# Measuring Transmitter equalization filter coefficients at the end of a channel with loss

Charles Moore Avago Technologies

IEEE802.3ba Clause 85.8.3.3 specifies a way of measuring transmitter transversal filter tap coefficients at TP2 after some amount of TP0 to TP2 loss, which could be up to 6.5dB at Nyquist, plus some chip and package attenuation. My simulations show that at these levels of loss the Clause 85 method gives reasonably accurate results although there is some error especially for  $c(-1)$ . On the other hand for the Clause 92 TP0-TP2 with higher loss at Nyquist, simulations indicate significant inaccuracy especially for  $c(-1)$ .

Precursor ( $c(-1)$ ) measured vs actual

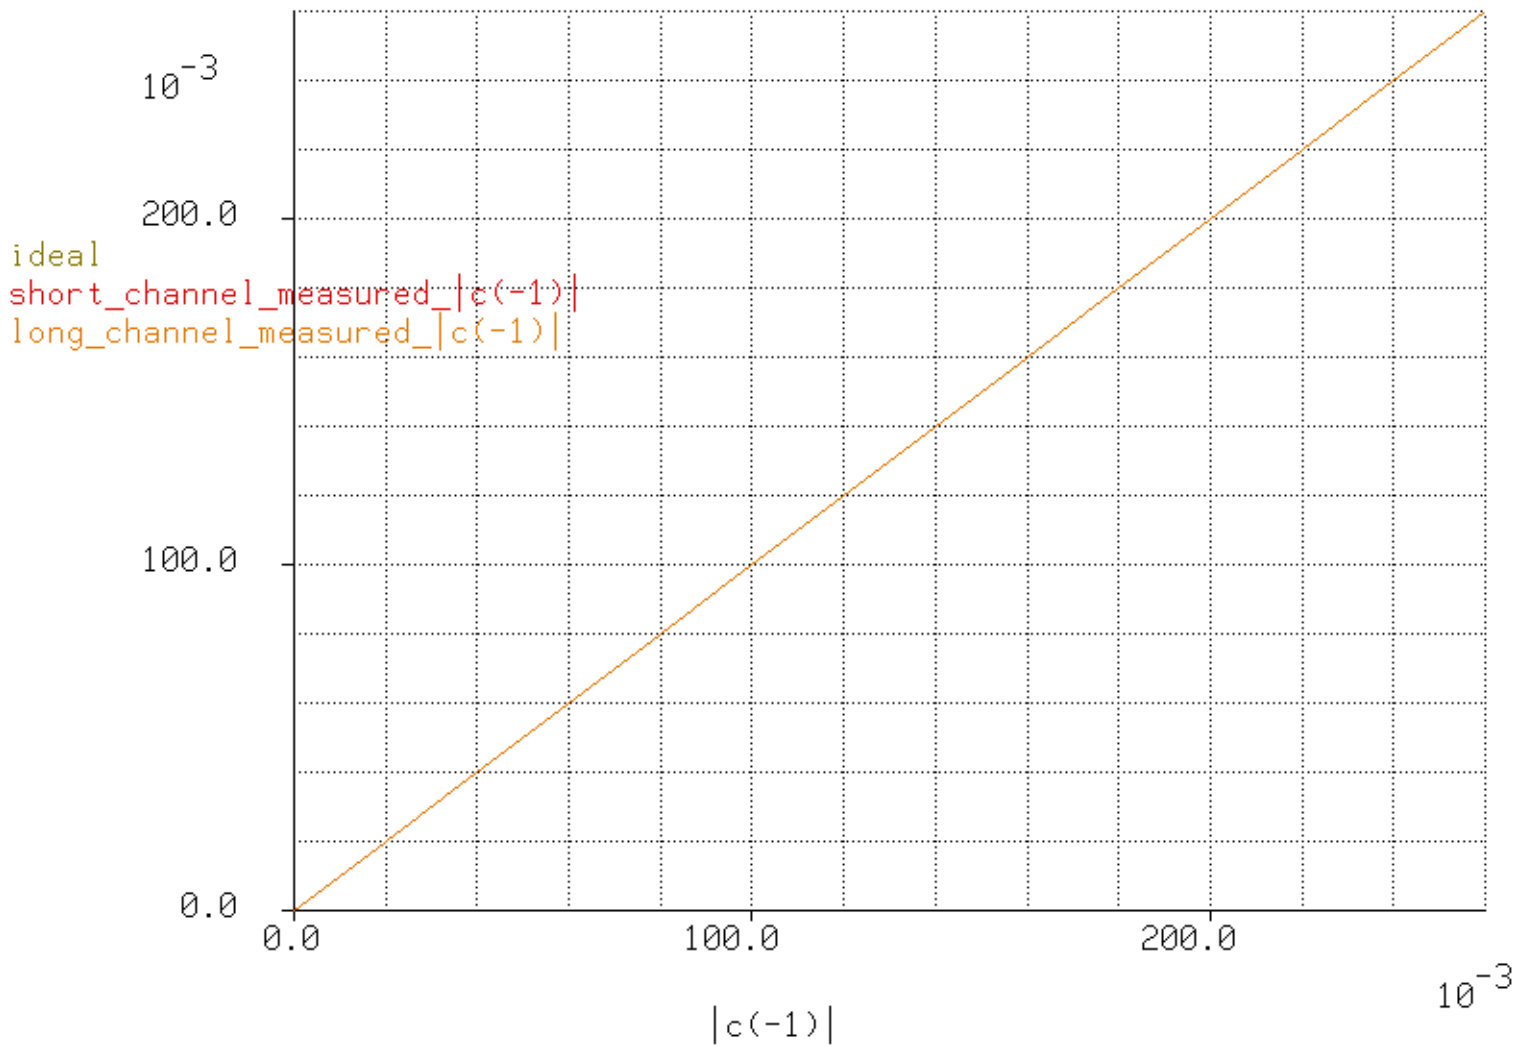
The post cursor measurement looks pretty good with a maximum error of only about 0.02 for the long channel. Pre cursor measurement is not too bad for the short channel, maximum error  $<0.02$ , which means that the clause 85 method is good at the loss level it was intended for, but the error is substantial for the long channel,  $>0.07$ . We need something better for Clause 92.

The problem comes about because the method uses the rising edge as a timing reference. Pre cursor equalization moves the rising edge. When symbol space samples are made to create the sampled pulse, the reference, un-equalized pulse and the equalized pulse are sampled at different times and the equalization of the sampled pulse is not really valid and gives inaccurate results.

1. Find a better timing reference than the rising edge half height crossing point.
2. Find the best LMS fit of the equalized pulse to the sum of 3 symbol time spaced, weighted reference (unequalized) pulses, adjusting the timing of the start of the pulses to give the best LMS fit. The three weights are  $c(-1)$ ,  $c(0)$ ,  $c(1)$ .

I have tried method 2 on my simulated data and find the error small. Unless someone is ready to state that method 1 is workable and gives good results I recommend using method 2 and making suitable changes to Clause 92.8.3.7.
